Office Action Summary

09/887,337

SONG, IN DUK

DETAILED ACTION

FIG.5

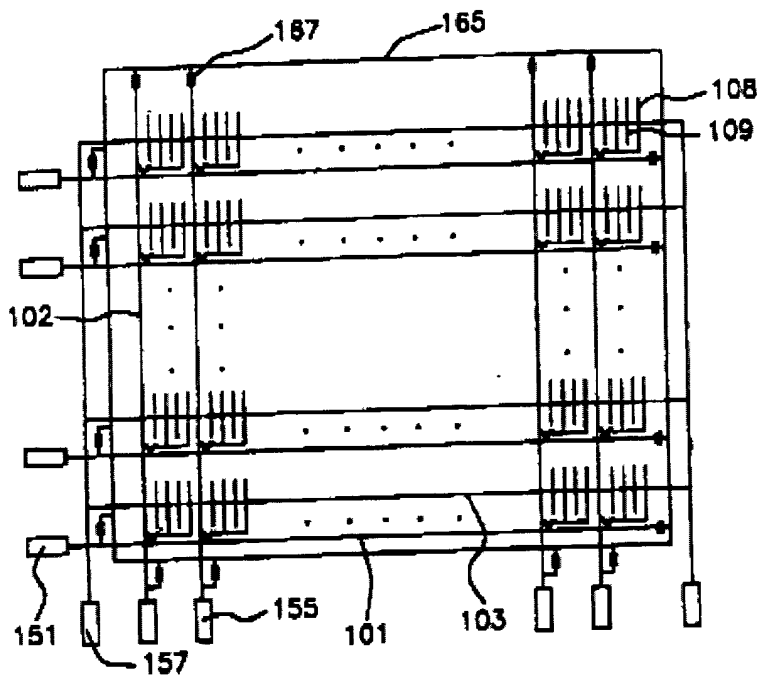
3. Komatsu discloses in col. 5, lines 40-65 and shows in Fig. 5 (reproduced below), an in-plane switching type liquid crystal display device comprising:

- a plurality of data lines (102) for applying data signals to a thin film transistor array;
- a plurality of gate lines (101) for applying gate signals to the thin film transistor array;
- a plurality of gate links extended from the plurality of gate lines (101) into an outer area of the thin film transistor array; and
- a plurality of common voltage lines connected to common voltage pads (157), being provided in such a manner to cross the plurality of gate links, for applying a common voltage to the thin film transistor array.

Komatsu also shows in Fig. 5 that the common voltage lines are parallel to the gate lines (101).

As to claim 7, Komatsu shows in Fig. 5 that the in-plane switching liquid crystal display device further comprising:

- a plurality of gate pads (151) connected to the gate links and electrically disposed between the gate links and an external power source; and
- a plurality of common voltage pads (157) connected to the common voltage lines and electrically disposed between the common voltage lines and the external power source.

As to claims 8-11 and 14, Fig. 5 of Komatsu also shows that the gate pads (151), data pads (155) and the common voltage pads (157) are located in an area outside of the thin film transistor array.

As to claims 12 and 13, Komatsu also shows in Fig. 5 that at least one common line that is parallel to the data line (102) crosses the gate lines (101) in an area between the gate pads (151) and the thin film transistor array.

As to claims 15 and 16, Komatsu shows in Fig. 5 that at least one common line crosses the data lines (102) in an area between the data pads (155) and the thin film transistor array.

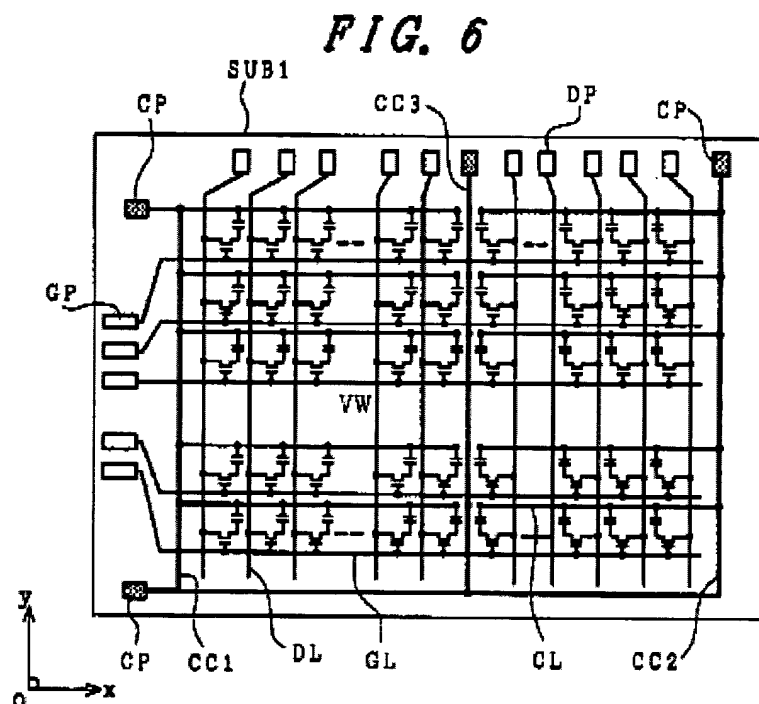
5. Ashizawa discloses in col. 9, lines 27-67 and shows in Fig. 6, an in-plane switching type liquid crystal display device comprising:

- a plurality of data lines (DL) for applying data signals to a thin film transistor array;
- a plurality of gate lines (GL) for applying gate signals to the thin film transistor array;
- a plurality of gate links extended from the plurality of gate lines (GL) into an outer area of the thin film transistor array; and

- a plurality of common voltage lines (CC1, CC2) connected to common voltage pads (CP), being provided in such a manner to cross the plurality of gate links, for applying a common voltage to the thin film transistor array.

Ashizawa also shows (Fig. 6) that plurality of gate pads (GP) that are located outside of the thin film transistor array are connected to the gate links and electrically disposed between the gate links and an external power source.

Ashizawa also shows (Fig. 6) that a plurality of data pads (DP) are connected to the data links.

Ashizawa further shows (Fig. 6) that a common voltage line is parallel to the data lines (DL) and a common voltage line is parallel to the gate line (GL).
